Title - Sujet New 50 Man Living Units - Ferndale	
Solicitation No. - N° de l'invitation EZ899-131401/A	Amendment No. - N° modif. 002
Client Reference No. - N° de référence du client	Date 2012-10-23
GETS Reference No. - N° de référence de SEAG PW-\$PWY-005-6794	
File No. - N° de dossier PWY-2-35164 (005)	CCC No./N° CCC - FMS No./N° VME
Solicitation Closes - L'invitation prend fin at - à 02:00 PM on - le 2012-11-09	Time Zone Fuseau horaire Pacific Daylight Saving Time PDT
F.O.B. - F.A.B. Plant-Usine: <input type="checkbox"/> Destination: <input checked="" type="checkbox"/> Other-Autre: <input type="checkbox"/>	
Address Enquiries to: - Adresser toutes questions à: Pillay, Sal (PWY)	Buyer Id - Id de l'acheteur pwy005
Telephone No. - N° de téléphone (604) 775-9386 ()	FAX No. - N° de FAX (604) 775-6633
Destination - of Goods, Services, and Construction: Destination - des biens, services et construction: CSC - Ferndale Institution - Mission, BC

Refer to the attached Addendum No. 1 issued 23 October 2012.

The following changes in the tender documents are effective immediately. This addendum will form part of the contract documents.

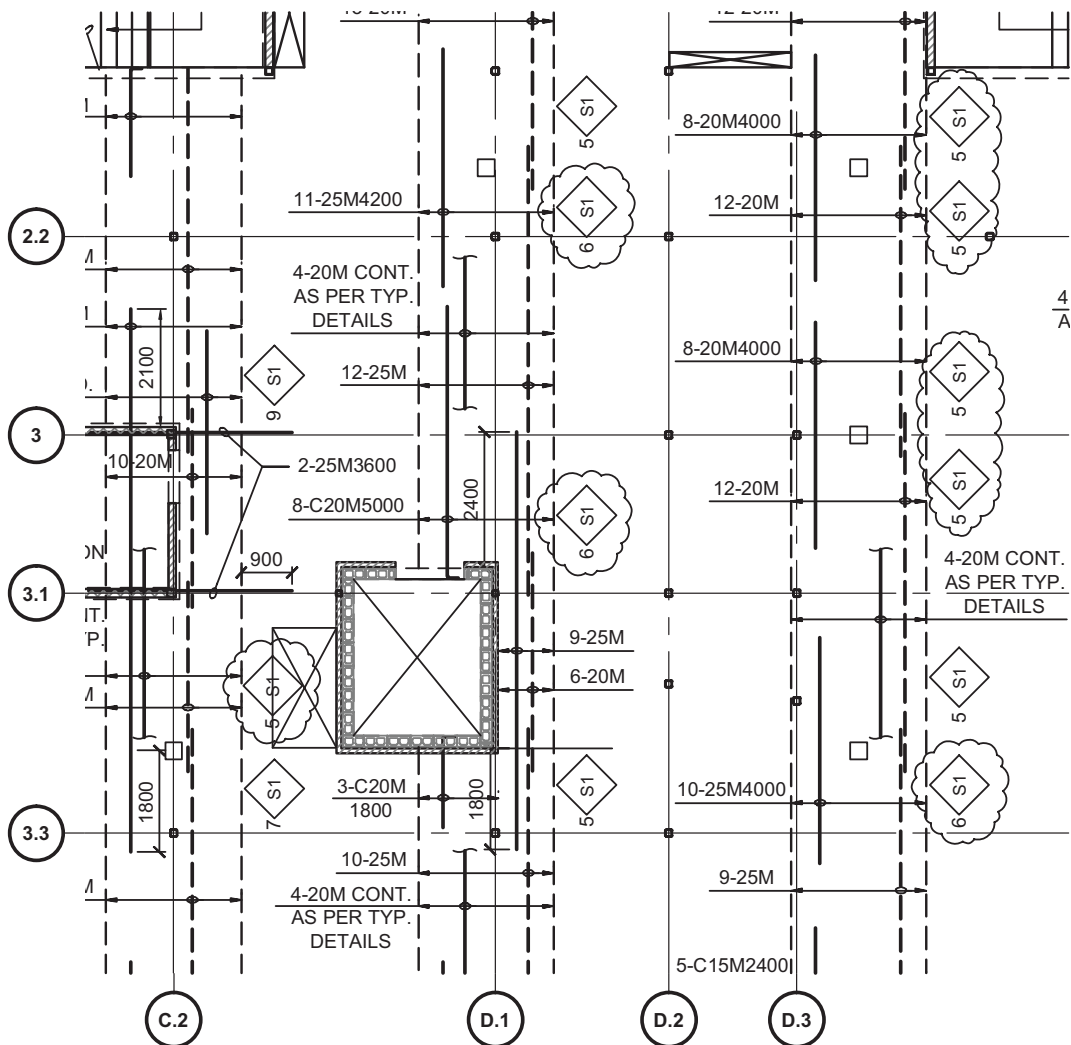
- (28) **Revise:** slab and shear stirrup reinforcement as per attached drawing S-AD-01.
- (29) **Add:** typical stirrup placement around each column for 400 deep slab band detail as per attached addendum sketch S-AD-02.
